Re: PART 573 NOTICE RE TAG AXLE INTERFERENCE

Safety Defect and Noncompliance Report Guide for Vehicles
PART 573 Defect and Noncompliance Report

Service Bulletin No. 276

Service Bulletin No. 277

Figure 2.

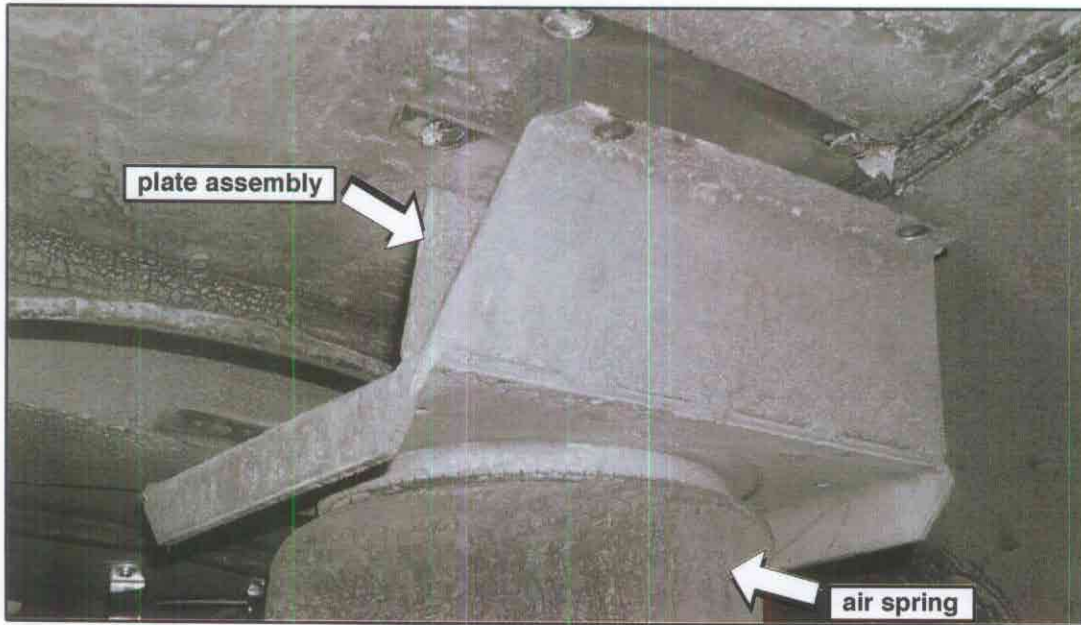
- 5. Remove and discard the plate assembly mounting hardware (Figure 2).

Figure 4. Tag axle suspension (partial front view).

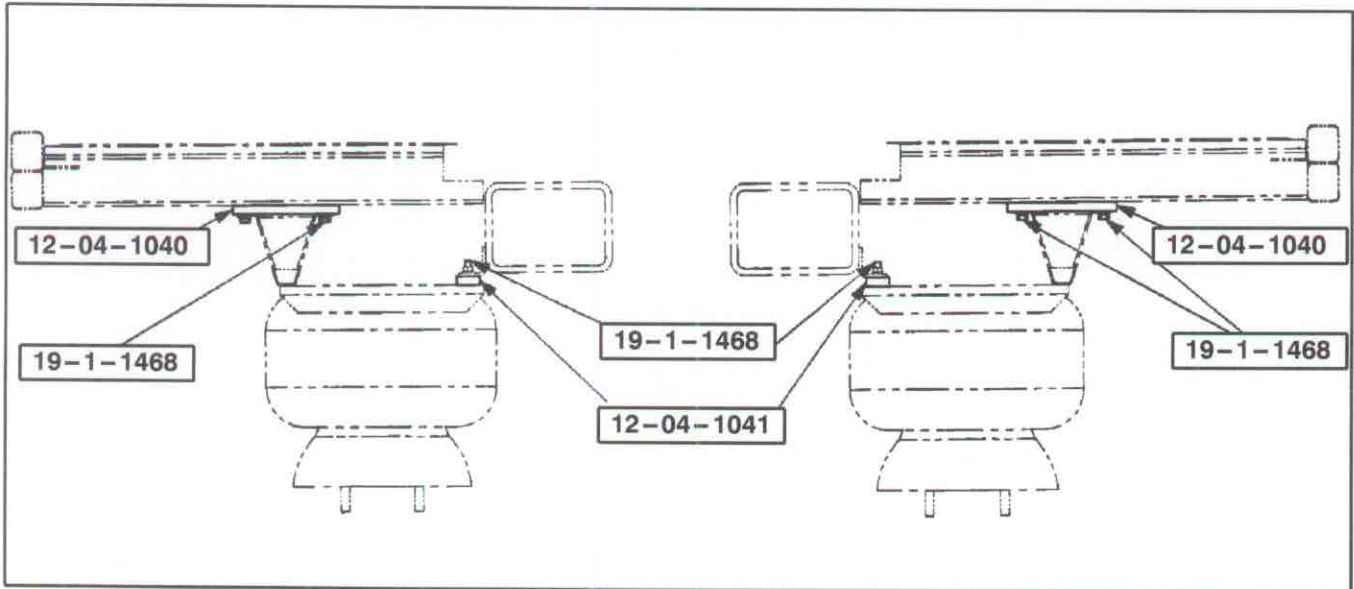
- 6. Install spacers (p/n 12-04-1040 and 12-04-1041) in the two locations shown in Figure 4., using the new plate assembly mounting hardware provided in the Parts list. Torque nut (p/n 19-3-314) to 11 ft.-lbs.

Figure 1.

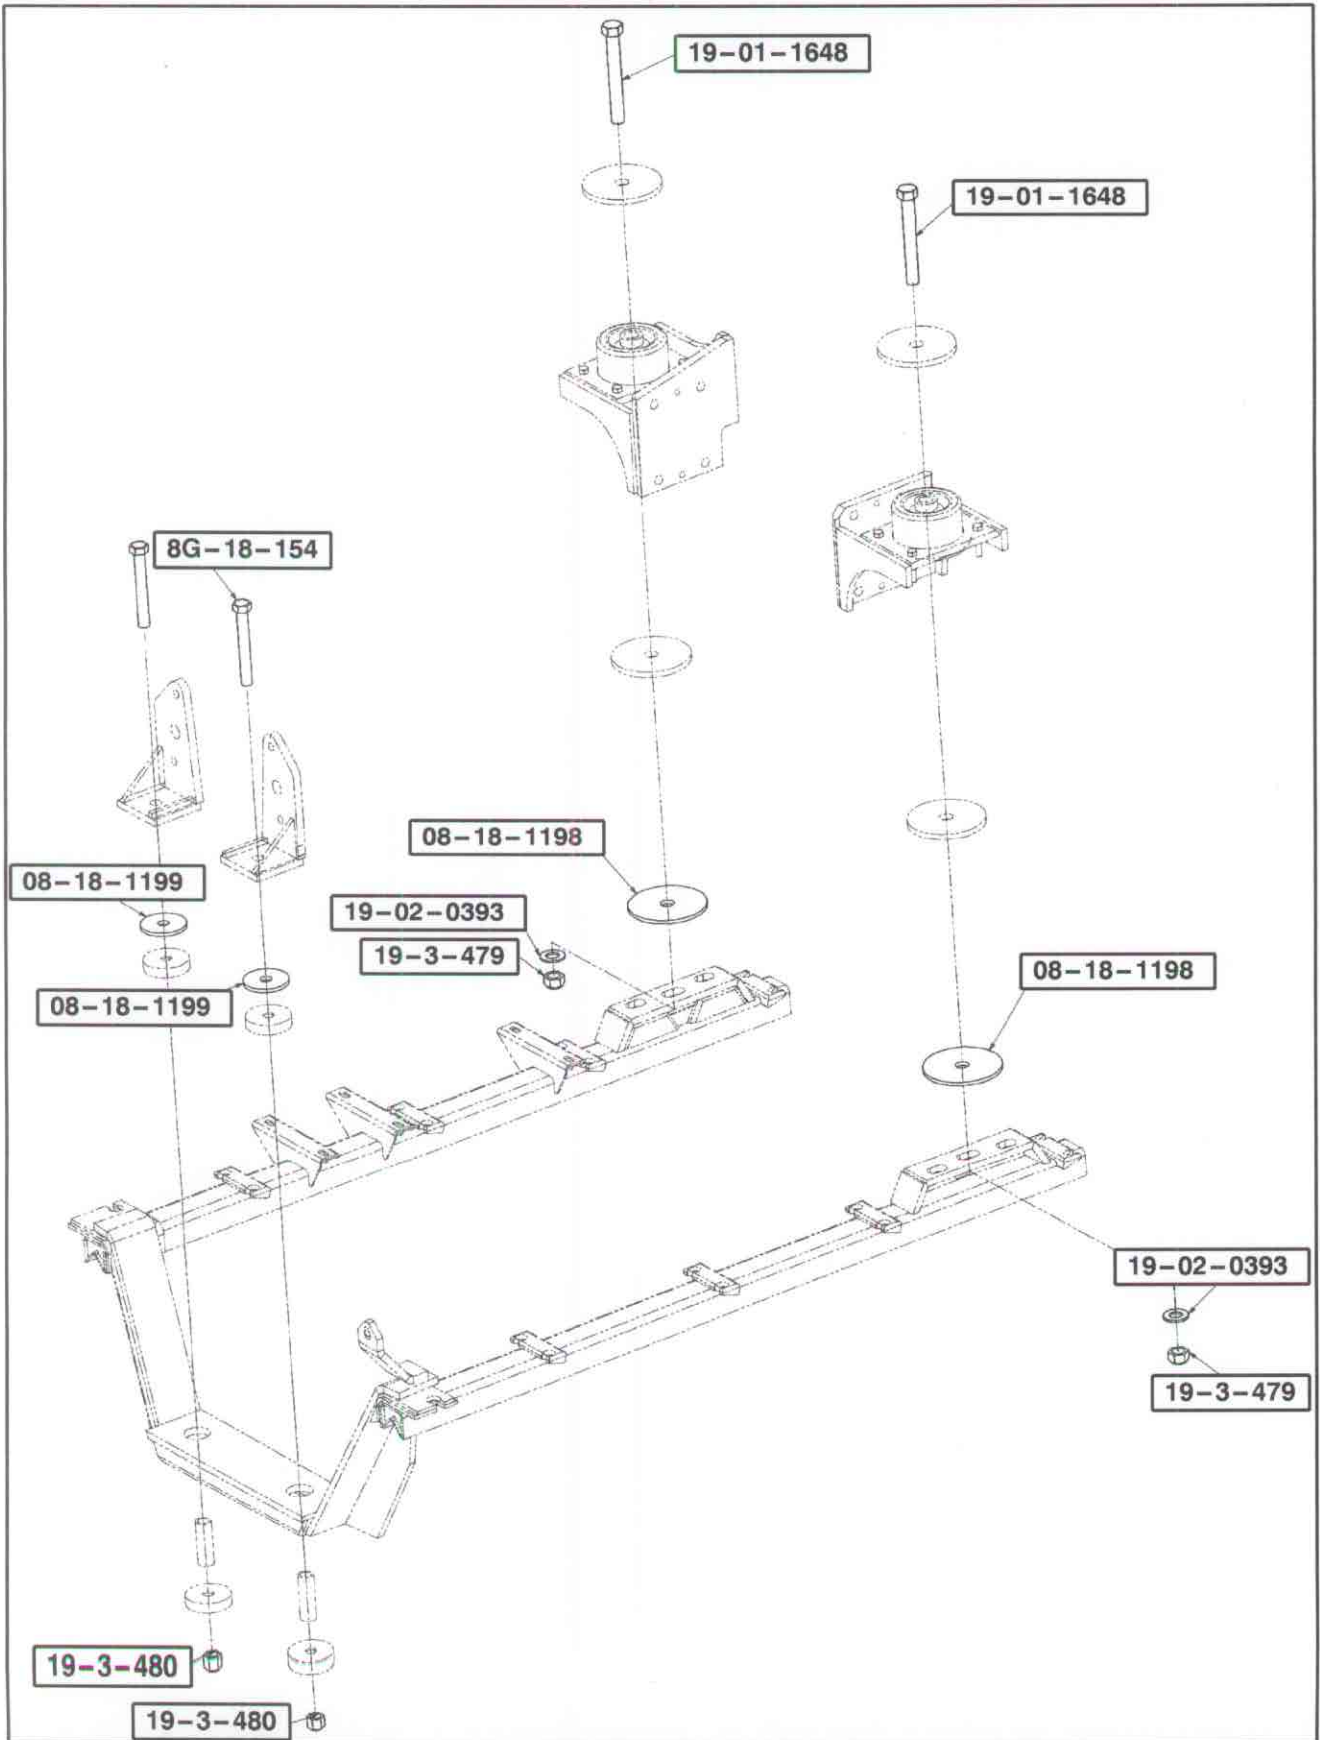
1. Turn the main battery disconnect switch to the " OFF " position. Chock both sides of the tires.
2. Open the engine compartment doors. Locate the engine remote and position the ENGINE RUN and ENGINE START to the OFF position.
3. Locate the engine cradle mounting hardware shown in Figure 1 (four locations).
4. Remove and discard the existing locknuts only from the four locations shown in Figure 1.

7. Remove and discard the existing fastener (and washer if applicable). Install appropriate shim (p/n 08-18-1198 or 08-18-1199) and new mounting hardware provided in Parts list. Tighten nut hand tight only.
8. Repeat Step 7. to next fastener.

9. Upon completion of installing the four shims and mounting hardware, lower the jack removing all stress from the engine. Remove the jack from under the coach.
10. Torque 19-3-480 to 285–385 lbs.-ft. Torque 19-3-479 to 451–546 lbs.-ft.

Figure 3. Reference photo.

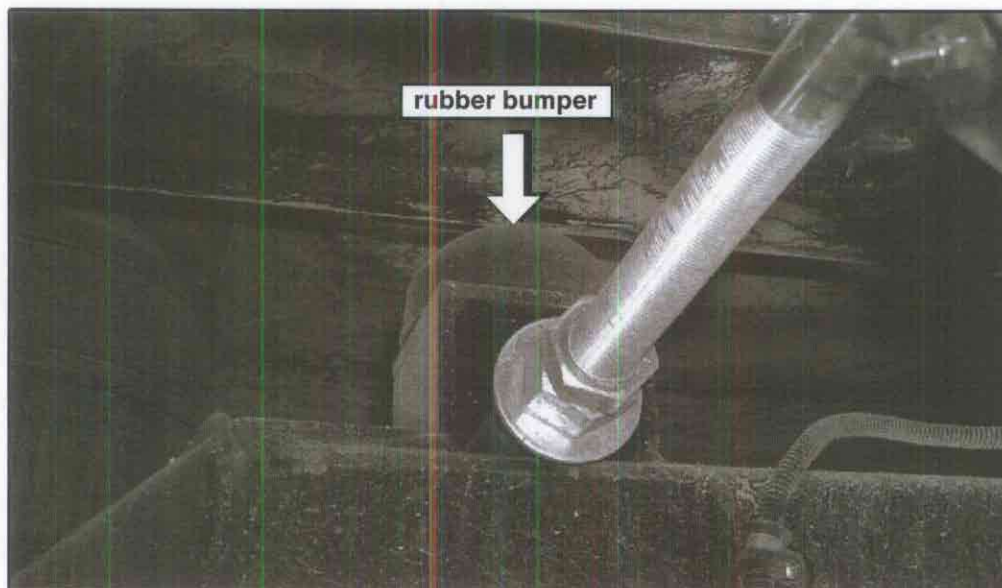
11. Locate the four existing rubber bumpers on the tag axle suspension assembly (Figures 3 and 5).

Figure 4.

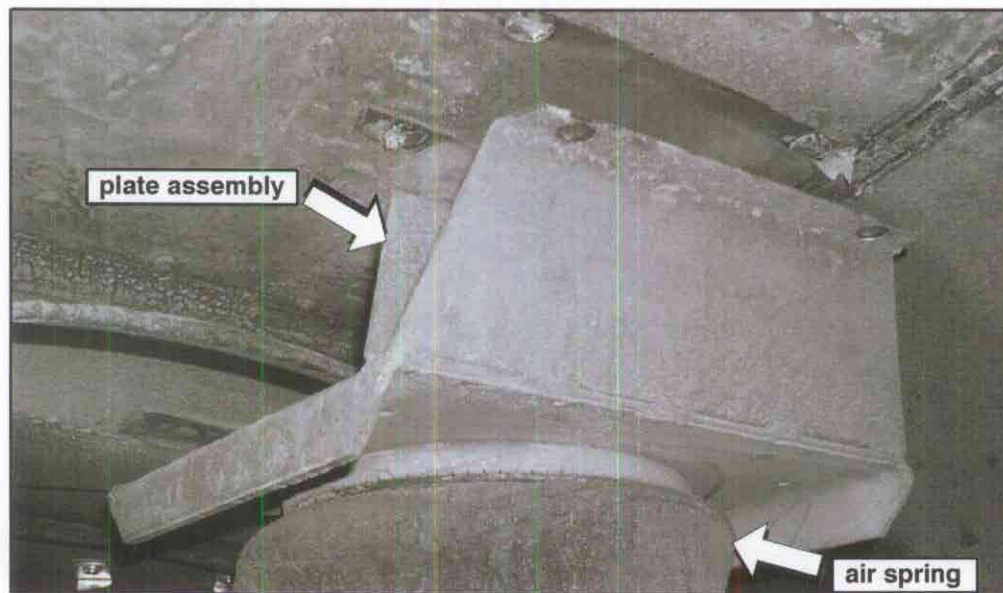
15. Remove and discard the plate assembly and mounting hardware (Figures 4 and 5).

Figure 5.

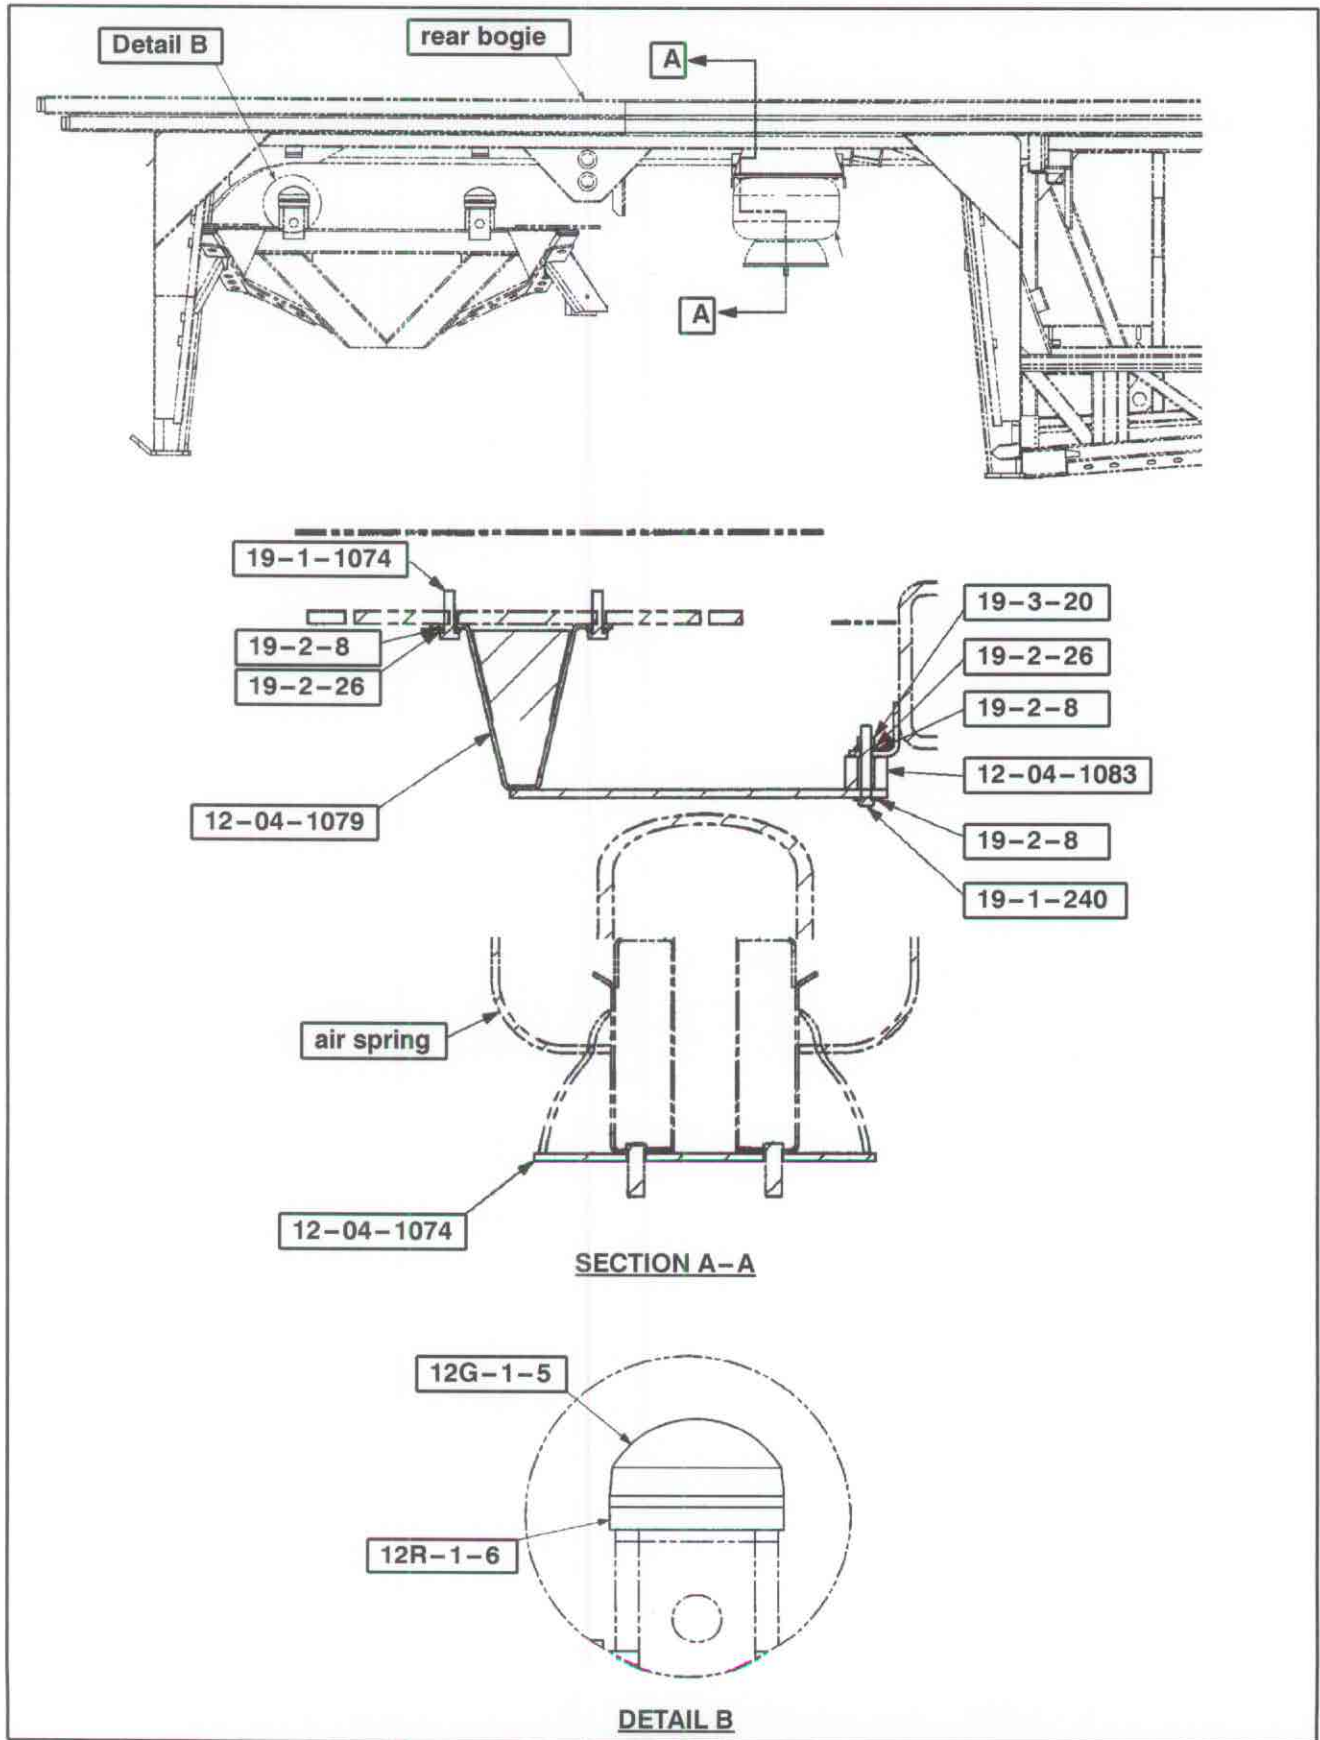
13. Disk sand the mounting surface in preparation of good reassembly.
14. Install the new rubber bumper (p/n 12G-1-5) and bumper block spacer (p/n 12G-1-6) (Detail B / Figure 5).

16. Install the new plate assembly (p/n 12-04-1079) and spacer (p/n 12-04-1083) in the locations shown in Figure 5., using the new plate assembly mounting hardware provided in the Parts list. Torque nut (p/n 19-3-314) to 18–22 ft.-lbs.
17. Align and position the spacer (p/n 12-04-1074) in the location shown in Figure 5.
18. After the coach has been lowered to the ground and lifts removed, return the tag axle dump valves to the ON (horizontal) position. Close the curbside, rear service department door.
